# UNITED STATES PATENT AND TRADEMARK OFFICE

APPLICATION NO.	FILING DATE	FIRST NAMED INVENTOR	ATTORNEY DOCKET NO.	CONFIRMATION NO.
10/821,188	04/09/2004	Bu-kil Jeong	1572.1338	8425

**Office Action Summary**

**DETAILED ACTION**

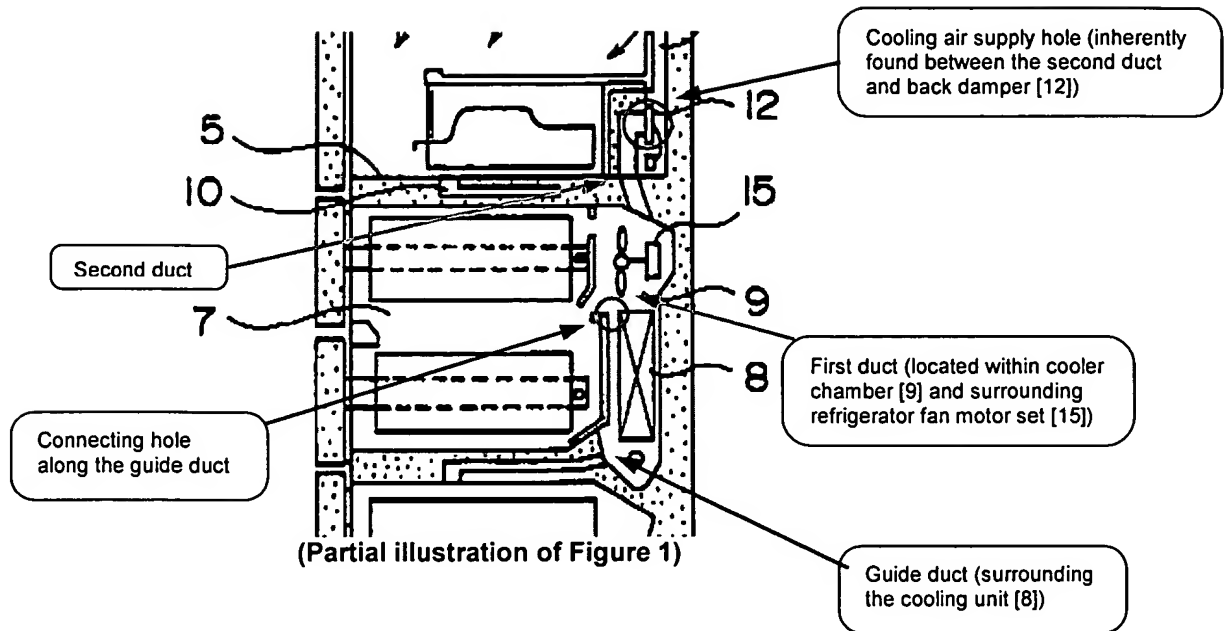
- a guide duct comprising a connecting hole on a side thereof (as seen in the partial illustration of Figure 1 below);
- the side ducts (18 – side cold-air duct) are bar shaped and extend to a lower portion of the refrigerating compartment (as seen in Figure 2).

- a first duct (as seen in the partial illustration of Figure 1 above) and a second duct (as seen in the partial illustration of Figure 1 above) in communication with the evaporating unit (as seen in Figure 1);

- the second duct comprising a cooling air supply hole (the hole is inherently found between the back damper [12] and second duct; as seen in the partial illustration of Figure 1 above);

- a guide duct in communication with the evaporating unit and comprises a connecting hole on a side thereof (as seen in the partial illustration of Figure 1 above).

FIG. 2

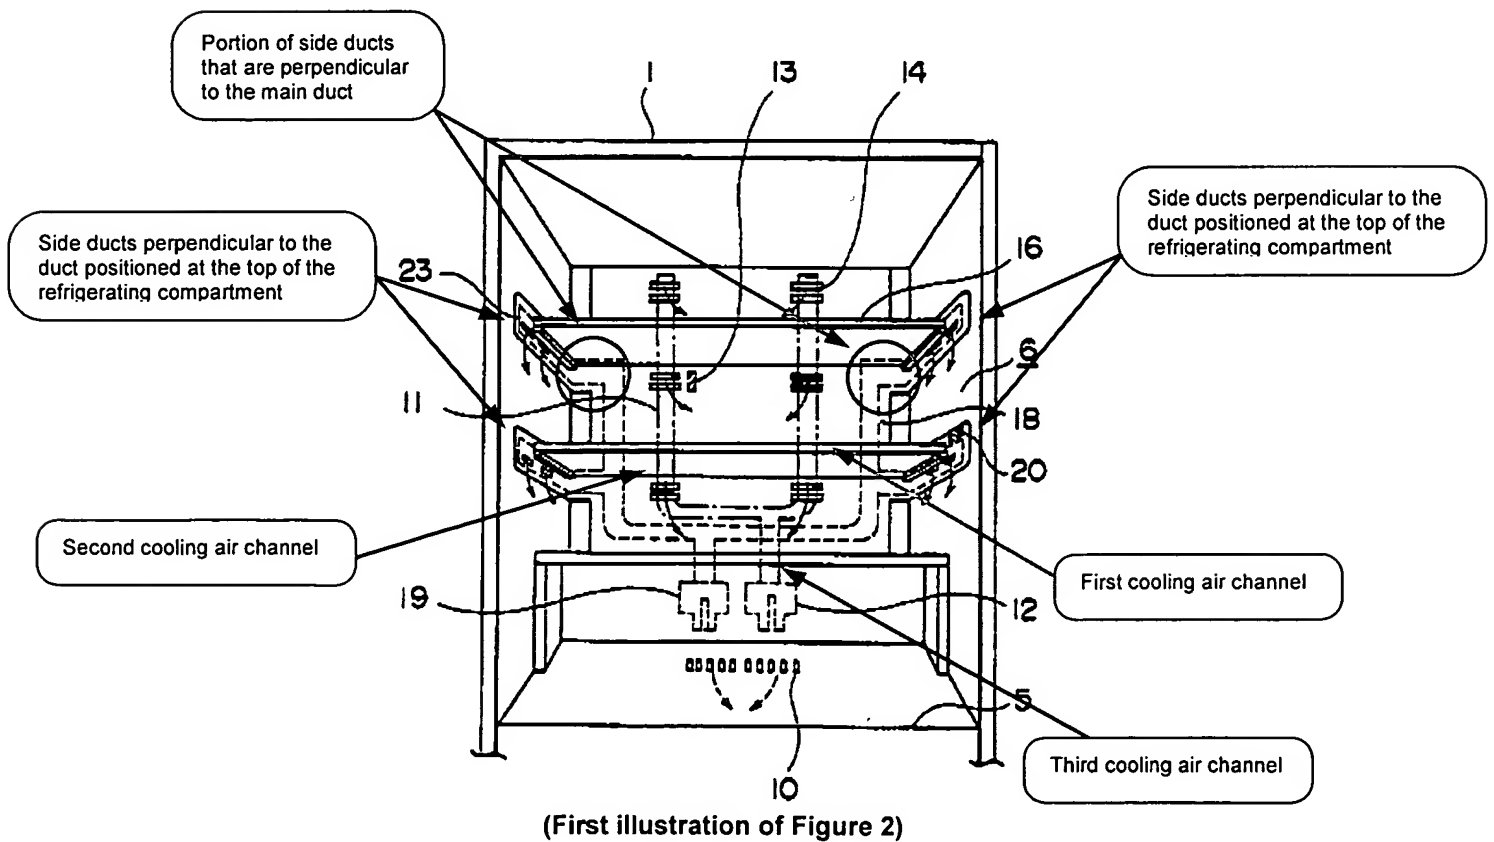
- side ducts provided on opposite sides of the refrigerating compartment perpendicular to the duct positioned at the top portion of the refrigerating compartment (as seen in the first illustration of Figure 2 below);

- a main duct (11 – back cold-air channel) provided at the top portion of the refrigerating compartment (as seen in Figures 1, 2);
- side ducts (18 – side cold-air supply duct) in communication with the main duct (as seen in Figure 2) and provided on opposite sides of the edge of the refrigerating compartment perpendicular to the main duct (as seen in the illustration of Figure 2 above);

- the main duct further comprises:
  - a first cooling air channel and a second cooling air channel on the inside thereof (as seen in the illustration of Figure 2 above);

- a main cooling air supply hole (14 – back blowoff ports) on the opposite sides of a front side thereof (as seen in Figure 2);
  - a third cooling air channel on the inside thereof (as seen in the illustration of Figure 2 above);

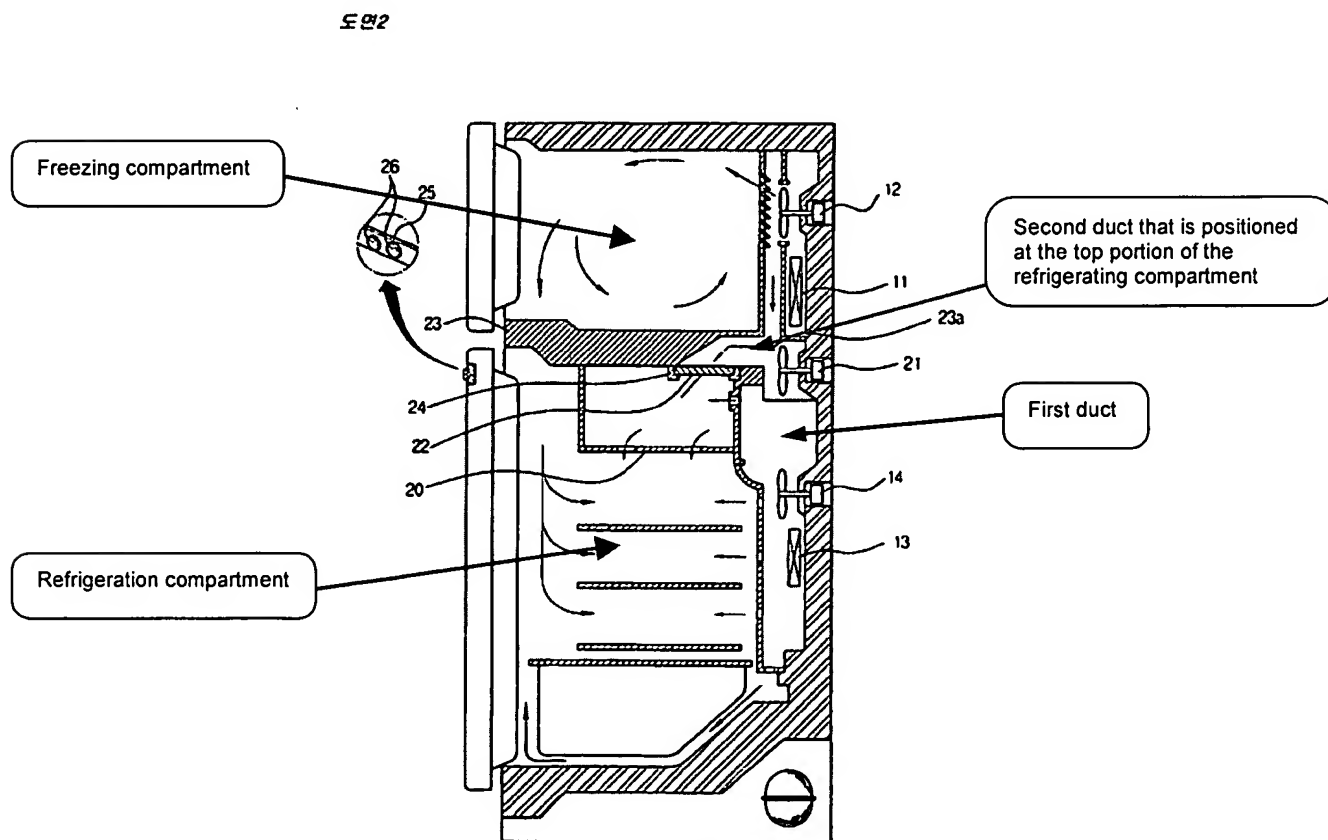
Korean Patent (KR 1999-39321) teaches of a refrigeration unit that is comprised of a freezing compartment, a refrigeration compartment, an evaporator (13), a first and second duct that are in communication with the evaporator (as seen in the illustration of Figure 2 below). Further disclosed is that the second duct is positioned at a top portion of the refrigeration unit (as seen in the illustration of Figure 2 below).

Regarding claim 1, it would have been obvious to one of ordinary skill in the art at the time the invention was made to modify the refrigerator of Igari et al. by incorporating a the second duct at a top portion of the refrigeration compartment, as taught by Korean Patent (KR 1999-39321), so that the refrigeration compartment can be more uniformly cooled by the air that is distributed by the duct.
